Re: Protest of the Northern Corridor Final Environmental Impact Statement and Proposed Resource Management Plan Amendments

Attachment: Protest of the Northern Corridor Final Environmental Impact Statement and Proposed Resource Management Plan Amendments Submitted to the BLM and USFWS by the Red Cliffs Conservation Coalition

Protest of the Northern Corridor Final Environmental Impact Statement and Proposed Resource Management Plan Amendments Submitted to the BLM and USFWS by the Red Cliffs Conservation Coalition

Map 3.5-1. Wildfires, Kernel Density Tortoise Abundance, and Northern Corridor Alignments

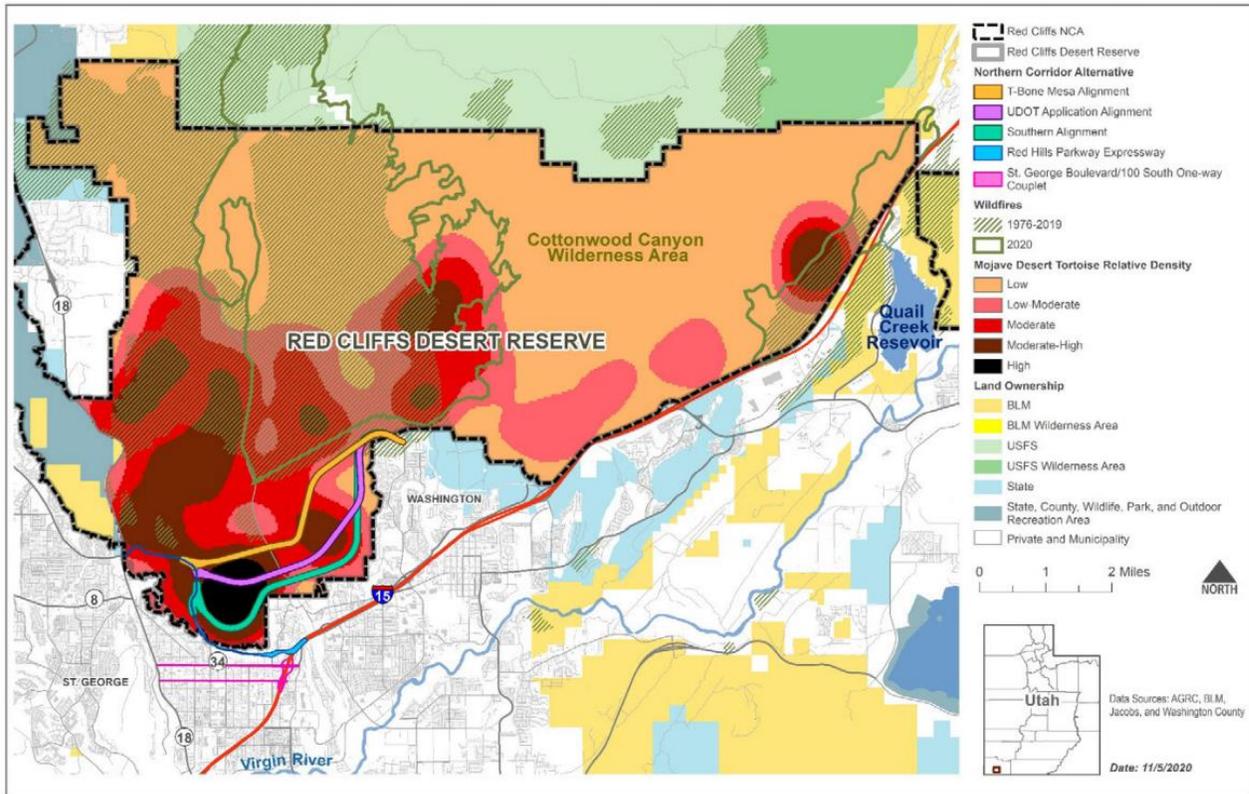
Map 3.5-1 from FEIS shows that the location of the Turkey Farm Road fire and the proposed UDOT’s application alignment effectively separate the western portion of Zone 3 from the eastern portion. This makes it very difficult for adult tortoises with large home ranges to move across Zone 3 and impossible for smaller tortoises. The fire and highway together can be seen as pseudo-barriers, at least until native perennial and annual plant species are re-established.
